Addendum #1

Date	Owner Property Number	Owner Building Number	BHDA Project Number
Fri, 21 Apr 2017	510-1409	1	1621

Project Designation	Project Address
Lakeridge 1, 4, 7 Remodel Orem UT Lakeridge Stake	158 East 1100 South Orem, Utah 84058

3 ENLARGED DEMOLITION PLAN
SCALE: 1/4" = 1'-0"

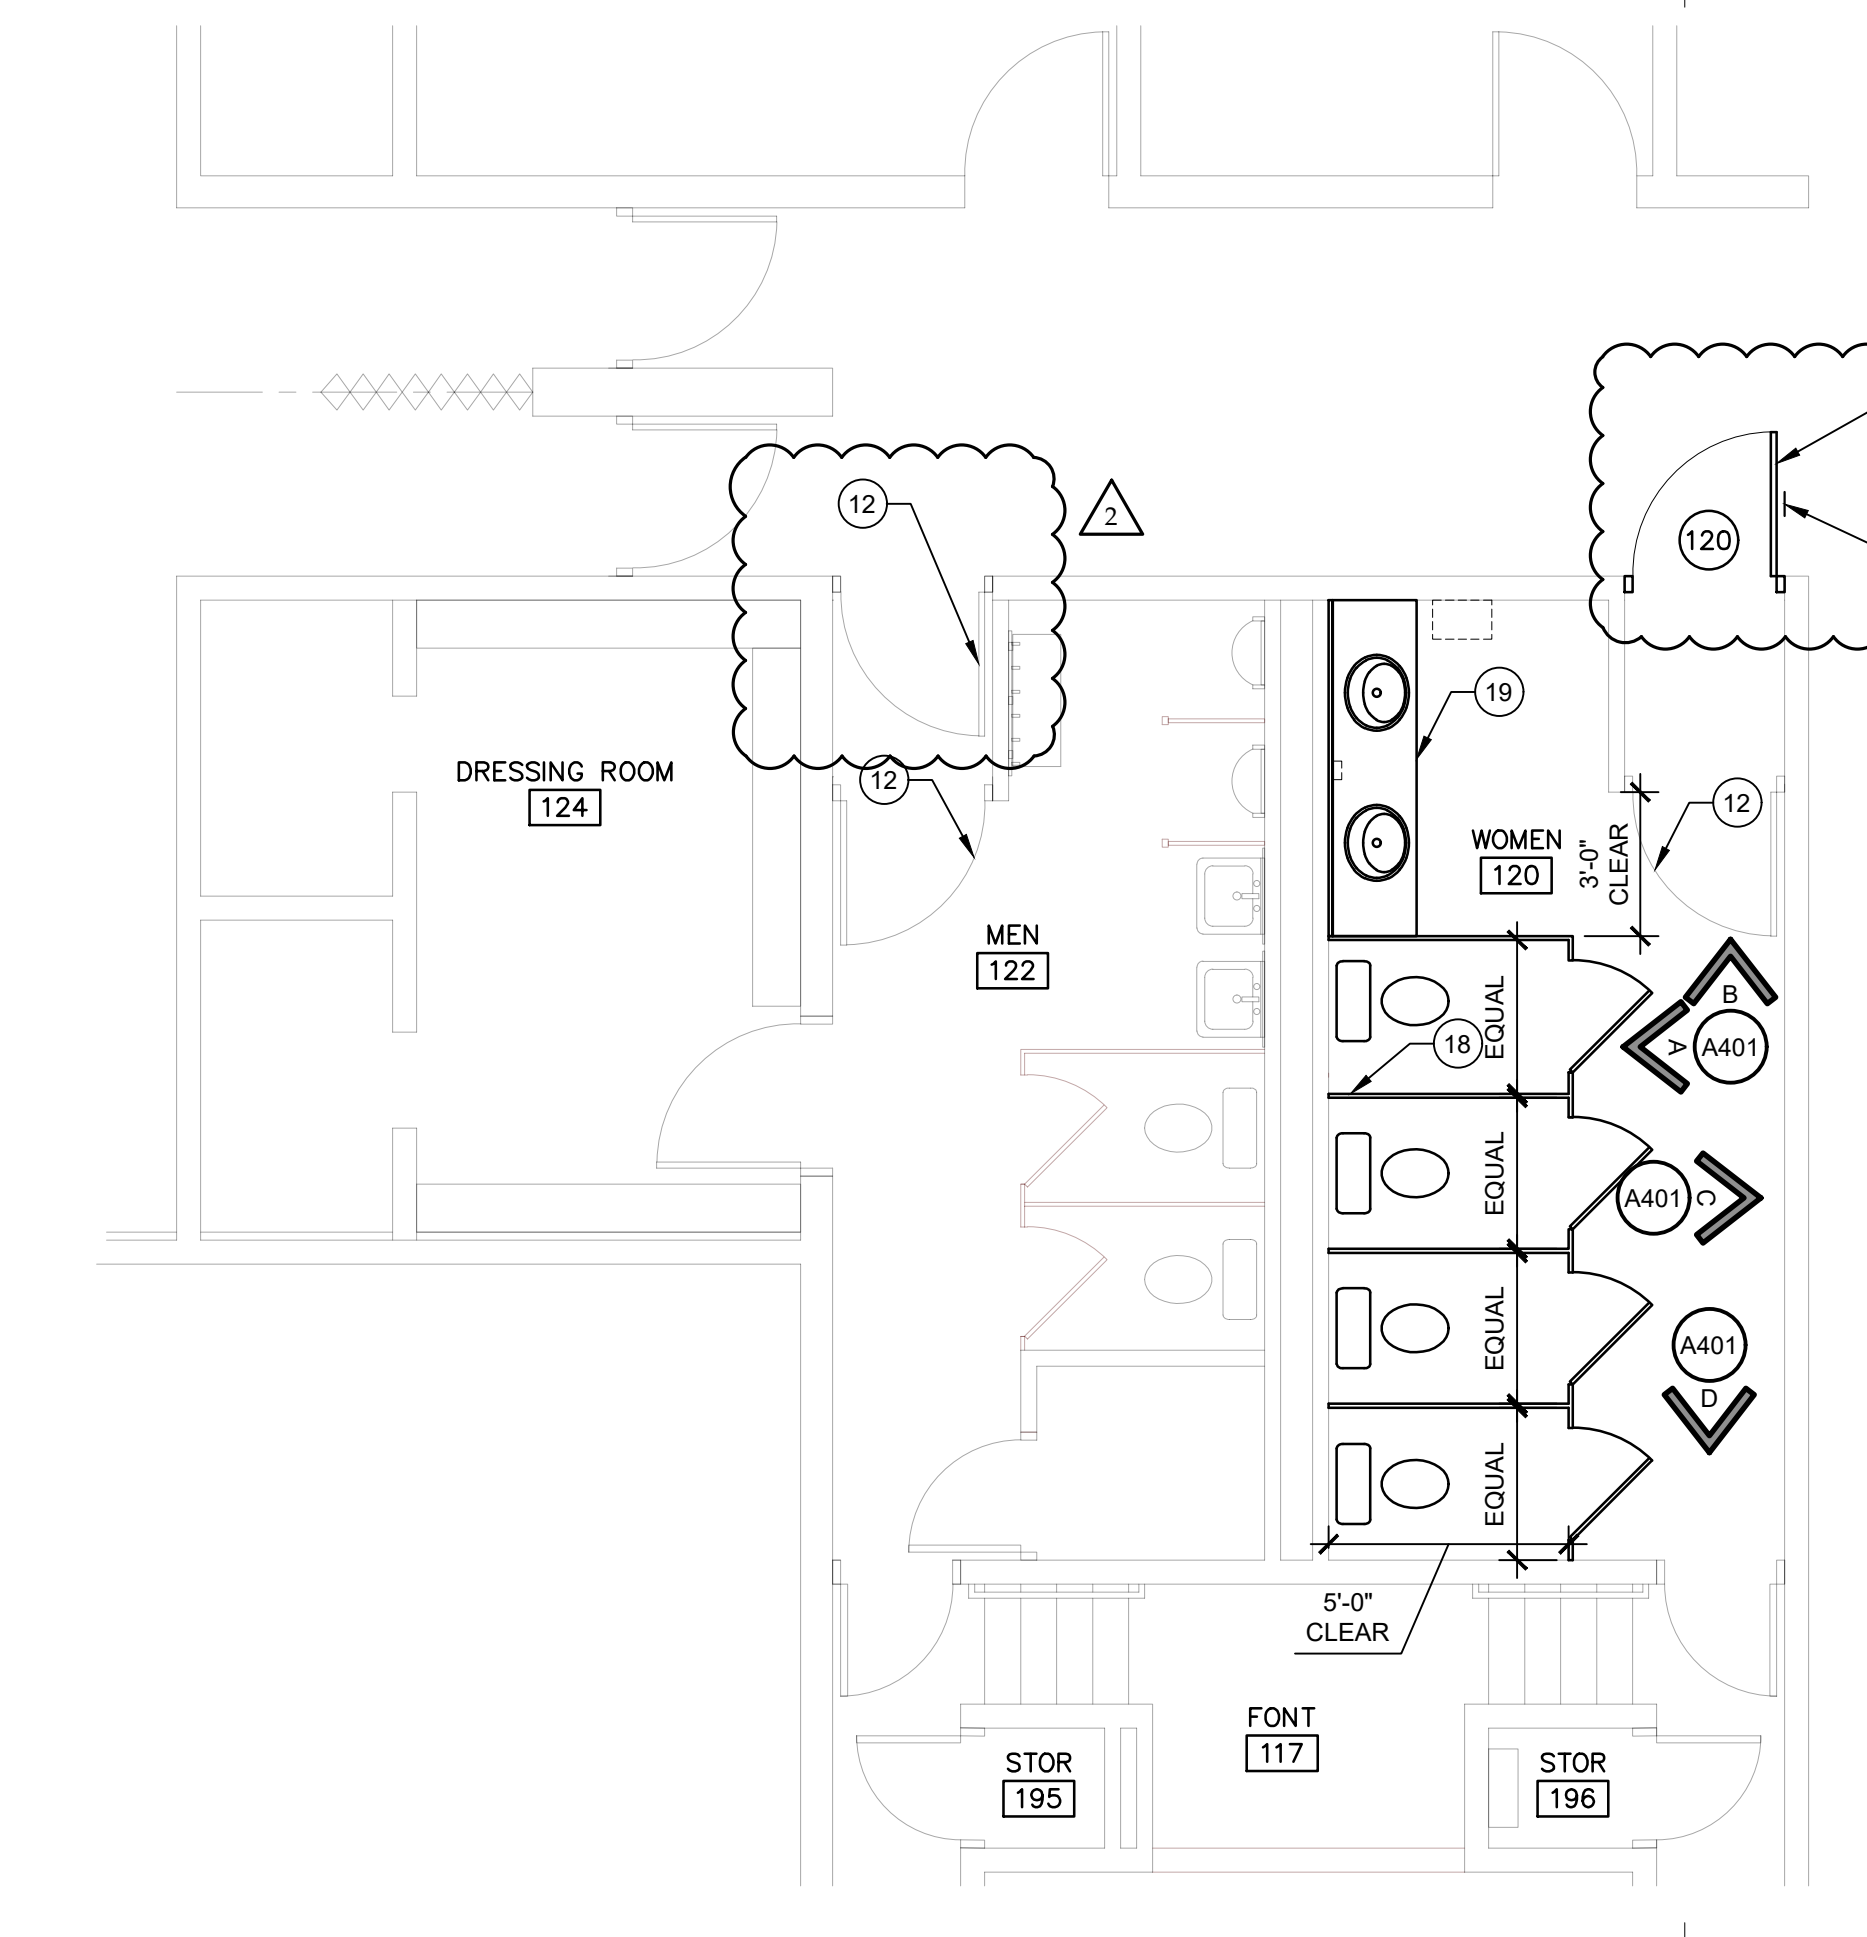
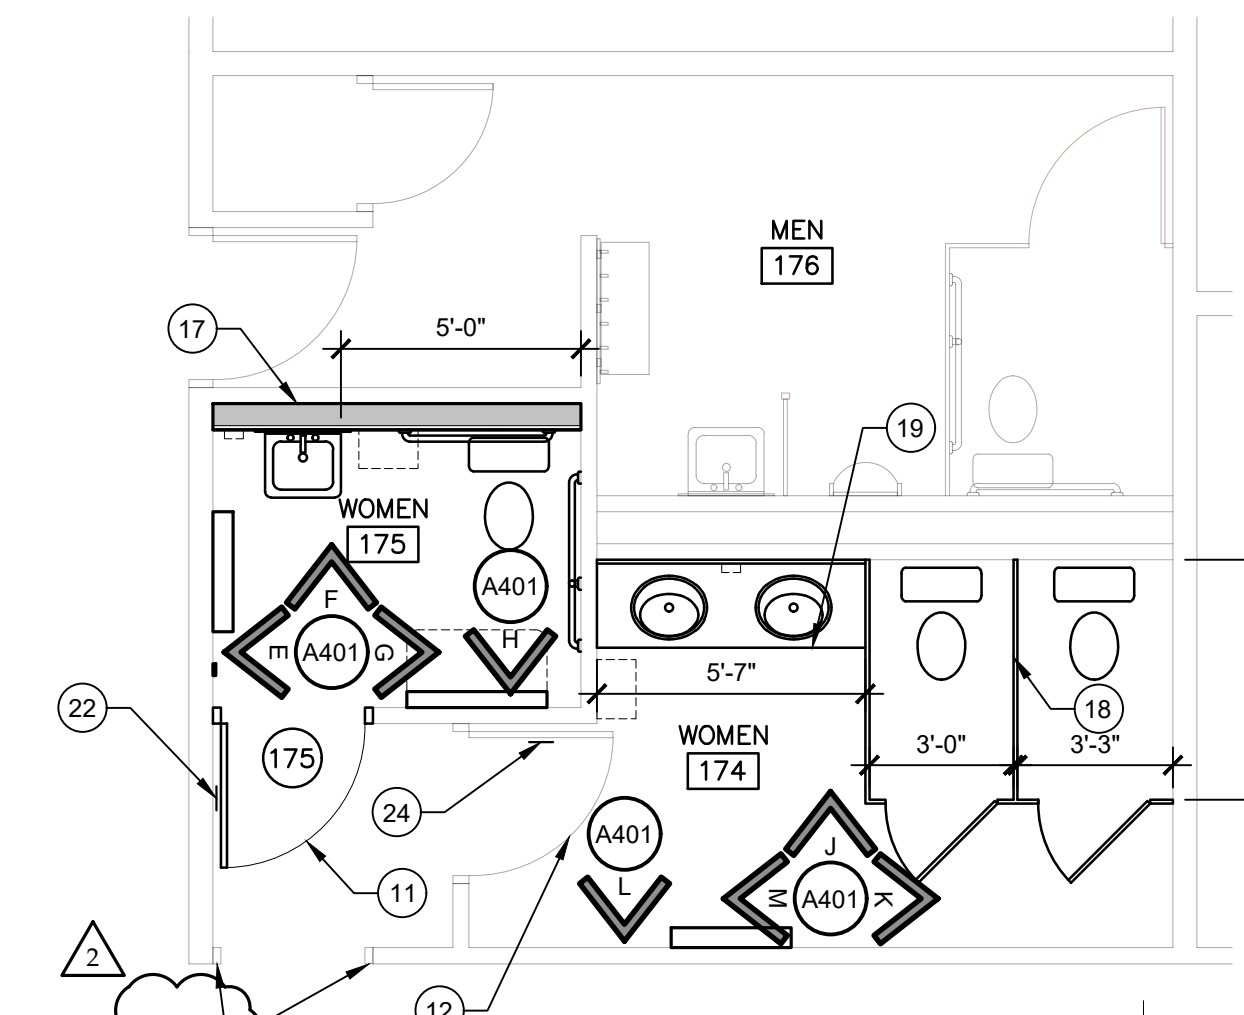
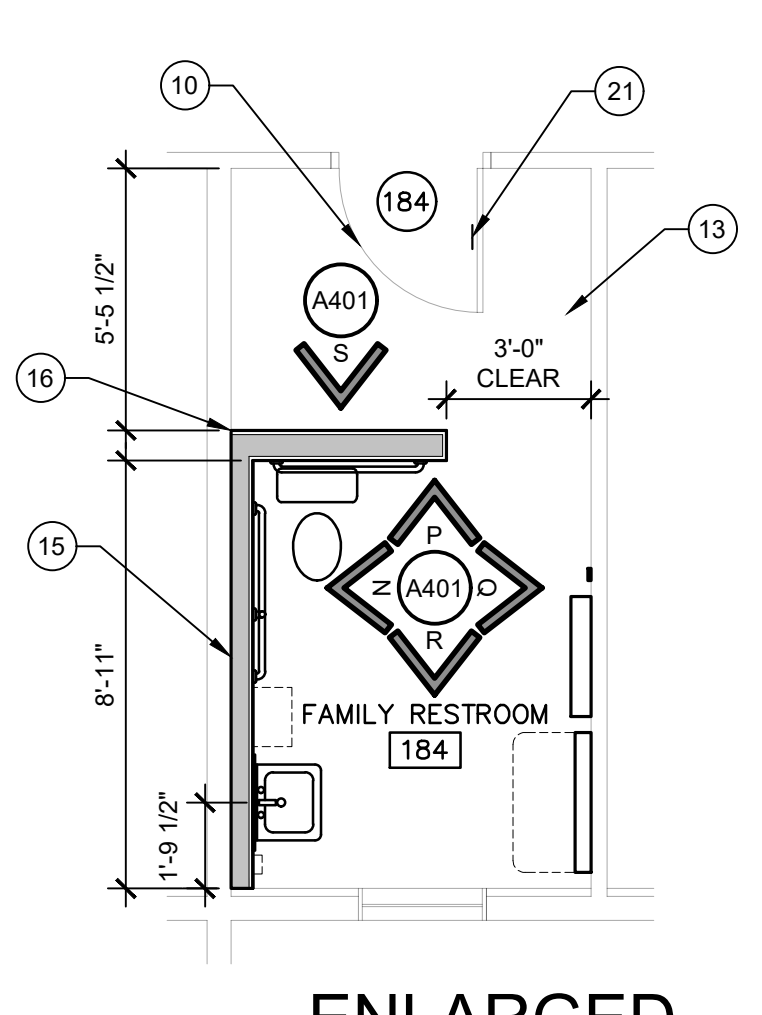
4.01. Sheet A101 Enlarged Demolition Plans and Enlarged Plans

A. Replace this sheet with the attached revised Sheet A101.
1. Modified notes about doors and door frames.
2. Clarified notes about work performed by the Owner and items salvaged to the Owner.
